Re: S/D 89-65 - JANET WHITE ADDITION

FINAL PLAT

STAFF REPORT

CASE NUMBER: S/D 89-65 - JANET WHITE ADDITION

JANET WHITE ADDITION

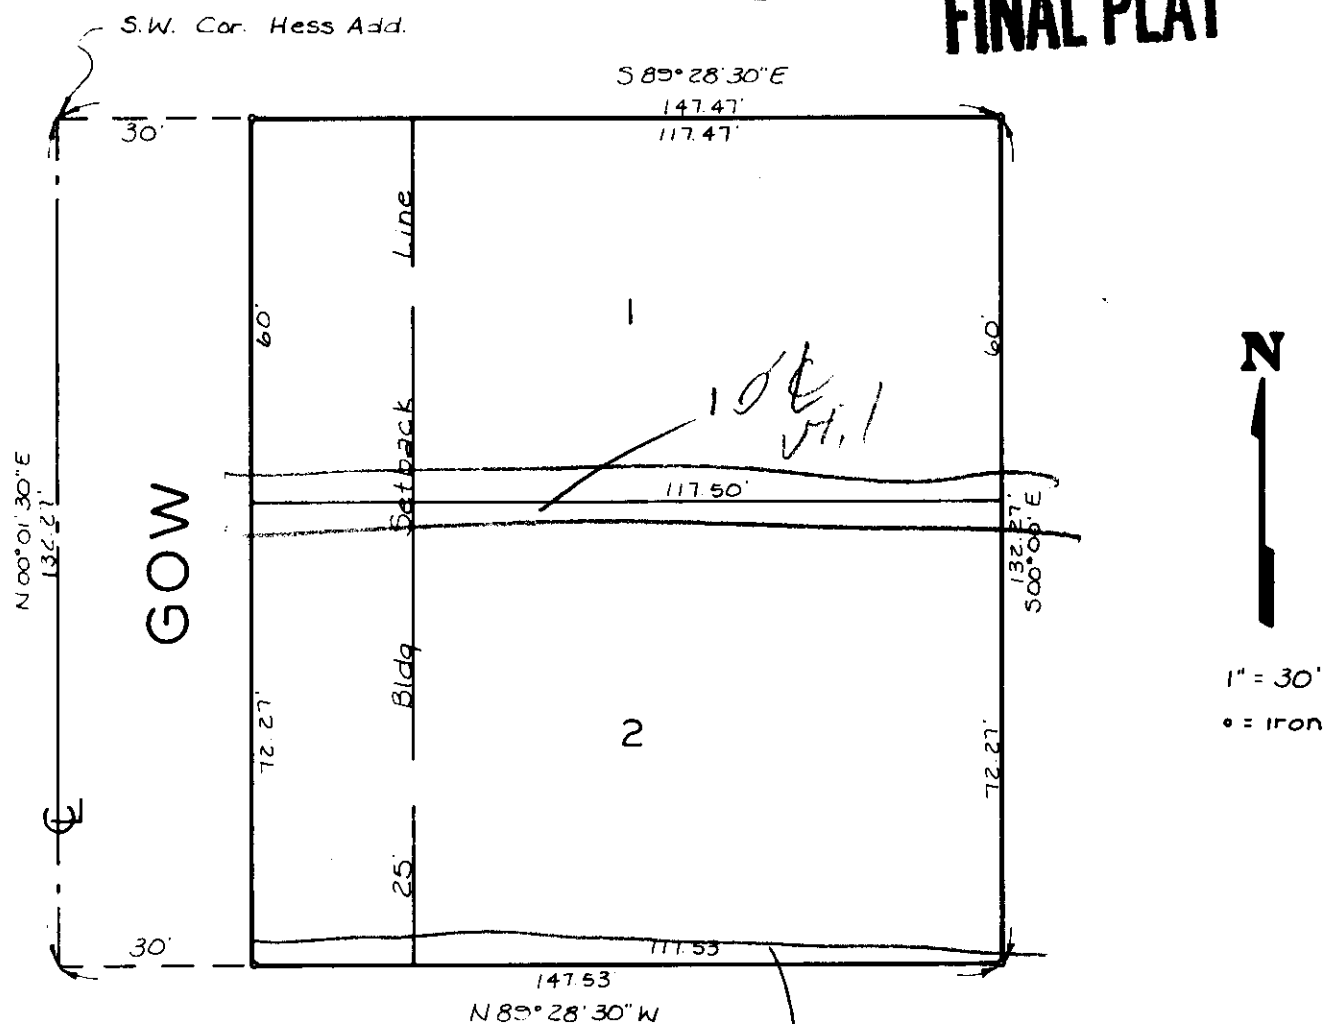
- A. The applicant shall guarantee the extension of City water to serve the lots being platted.
- B. The applicant shall attempt to obtain a valid petition for the paving of Gow from the south line of this plat, northward to existing pavement.

- C. If improvements are guaranteed by petition, a notarized certificate listing the petitions shall be submitted to the Planning Department for recording.

- D. Prior to scheduling this case before the City Council, the fence which encroaches into the street right-of-way being dedicated by this plat must be removed. Once the fence has been removed, a letter so stating shall be submitted from the platting engineer.

- E. The applicant shall dedicate by separate instrument, 4-feet of additional utility easement, off-site along the east line of this plat adjacent to the existing sanitary sewer line and easement.

- F. The final plat tracing shall indicate the utility easements requested by K.G. & E.; described as a 10-foot center line between Lots 1 and 2 and the south 5-feet of Lot 2. The platting engineer's text shall reference these utility easements as being dedicated to and for the public.

- G. The applicant shall install or guarantee the installation of all utilities and facilities which are applicable and described in Article 8 of the MAPC Subdivision Regulations.

- H. The applicant's engineer is advised that the Register of Deeds is requiring the name(s) of the notary public, who acknowledges the signatures on this plat, to be printed beneath the notary's signature.

- I. To receive mail delivery without delay, and to avoid unnecessary expense, the applicant is advised of the necessity to meet with the U.S. Postal Service Growth Management Coordinator (phone 316-946-4527) prior to development of the plat so that the type of delivery, and the tentative mailbox locations can be determined.

- J. Perimeter closure computations shall be submitted with the final plat tracing. Section 5-101(c).
- K. Recording of the plat within 30 days after approval by the City Council.
